Access Compliance Report

Public Rights-of-Way

Intersection ID: 30004	Main Street: DAY_LILLY_LN	Cross Street: MANDY_PLACE_CT	Location: NW
ADA ID: A3998ABC9D62	Ramp Type: BlendTrans1	Initial Pass/Fail: Fail	Overall Compliance: No
		Severity Score: 10

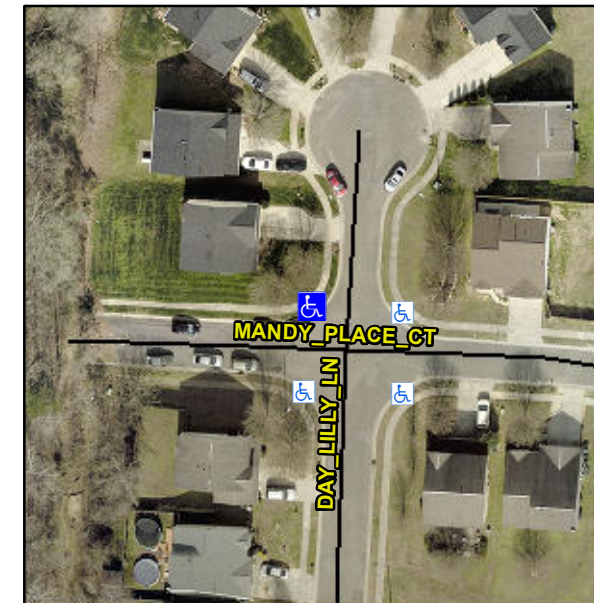
Not Found, R304.5.1, R304.5.3

Compliance	Description	Data	Compliance	Description	Data
N/A	Ramp Length (in)	48.5	Yes	BlendTrans Slope (%)	3.1
No	Ramp Width (in)	43.5	No	BlendTrans XSlope (%)	3.5
N/A	Flare Type LT	N/A	N/A	Flare Type RT	N/A
N/A	Flare Slope LT (%)	N/A	N/A	Flare Slope RT (%)	N/A
N/A	Flare Traversable LT?	N/A	N/A	Flare Traversable RT?	N/A
N/A	Landing Length (in)	N/A	N/A	DWS Provided?	N/A
N/A	Landing Width (in)	N/A	N/A	DWS Contrast?	N/A
N/A	Landing Slope (%)	N/A	N/A	DWS Length (in)	N/A
N/A	Landing X Slope (%)	N/A	N/A	DWS Full Width?	N/A
N/A	Landing Curb? (Y/N)	N/A	N/A	DWS Offset (in)	N/A
N/A	Shared Landing?	N/A			
N/A	Gutter Ponding?	N/A	N/A	Gutter Slope (%)	N/A
N/A	Gutter Lip Ht (in)	N/A	N/A	Gutter X Slope (%)	N/A
N/A	Painted X Walk1?	No	N/A	Painted X Walk2?	No
	X Walk 1 Direction	To S		X Walk 2 Direction	To E
	X Walk 1 Width (in)	N/A		X Walk 2 Width (in)	N/A
	X Walk 1 Slope (%)	4.8		X Walk 2 Slope (%)	1.6
	X Walk 1 X Slope (%)	2.0		X Walk 2 X Slope (%)	4.5

Remove & Replace Curb Ramp With Two New Directional Ramps or Equivalent.
